FILE P.I. # 0011738

SUBJECT APPROVED CONCEPT REPORT

**DEPARTMENT OF TRANSPORTATION
STATE OF GEORGIA
PROJECT CONCEPT REPORT**

Description: SR 3/US 41/Cobb Pkwy and Windy Hill Rd/CR 1720 Intersection Improvements and Queue Jumper Lanes.

TYPICAL SECTIONS

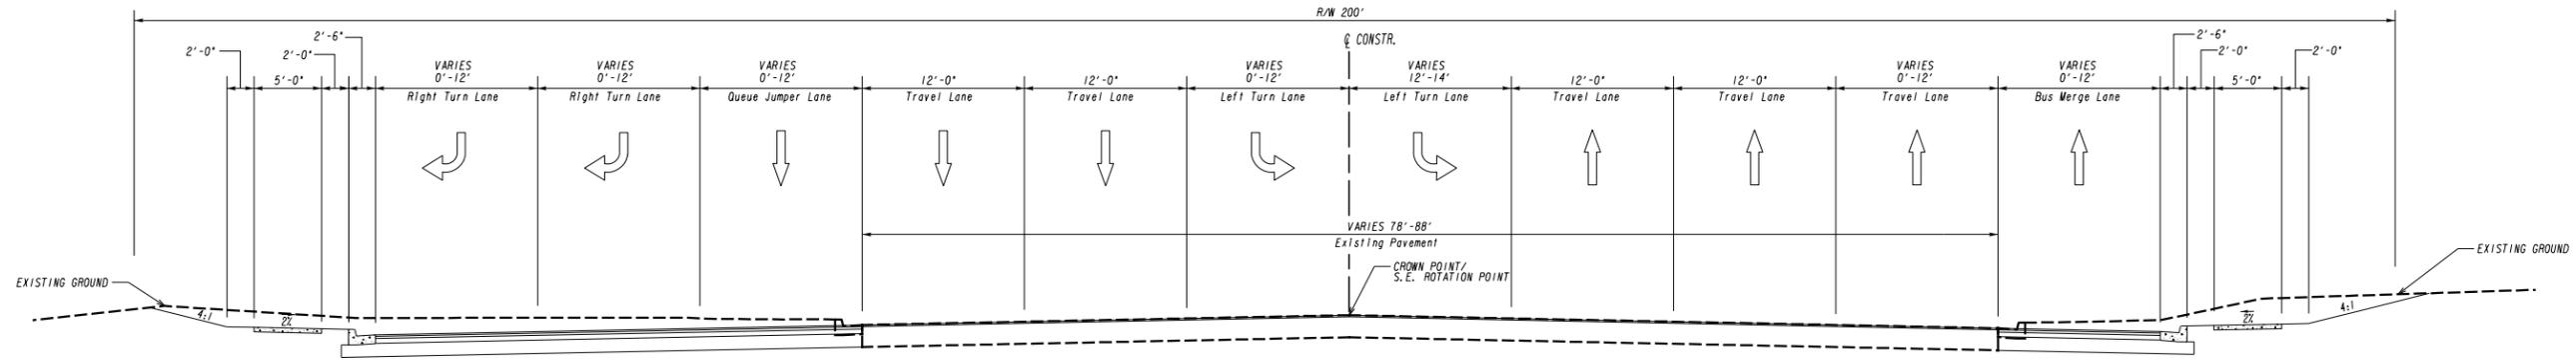
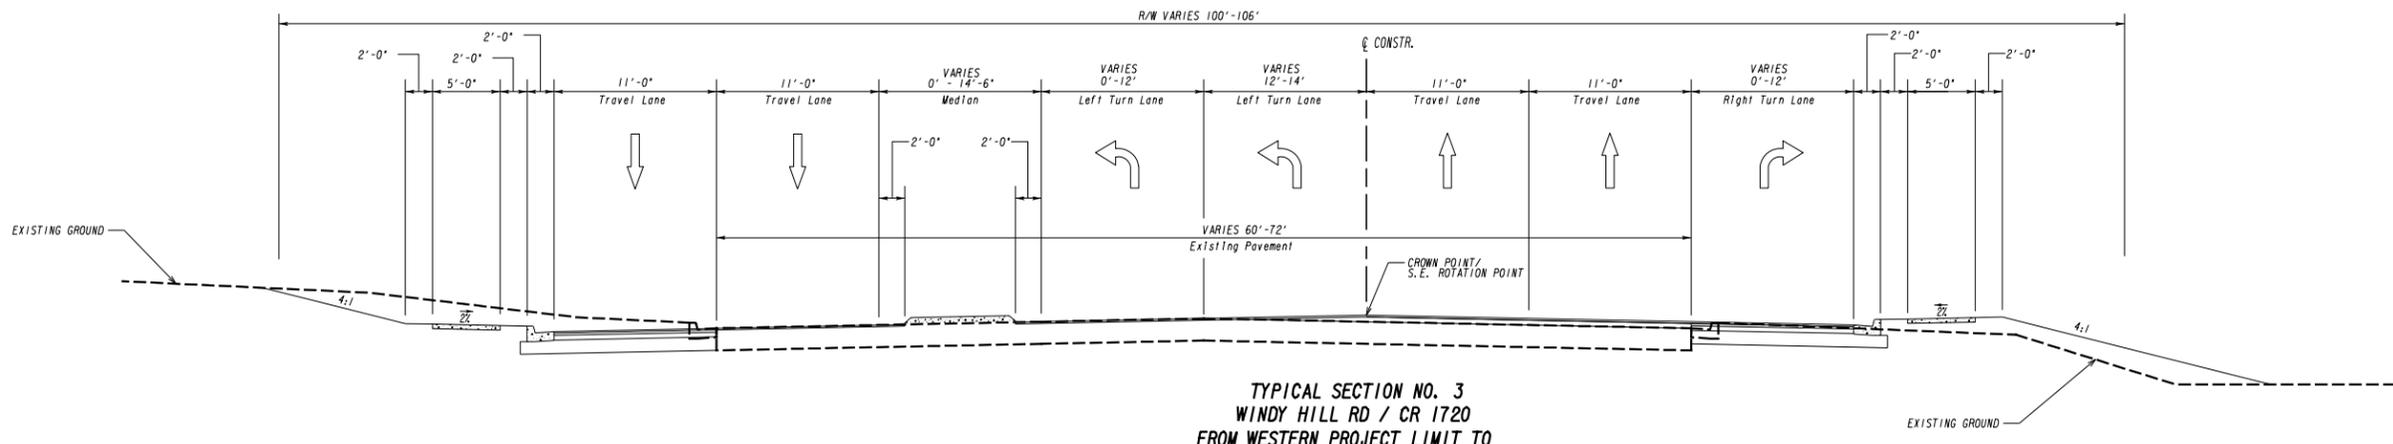
- **On the concept layout, maximize the left turn storage lengths on both Windy Hill Rd and Cobb Pkwy.**
 - **On the concept layout and typical sections, change the beauty strips from 5' to 2'.**
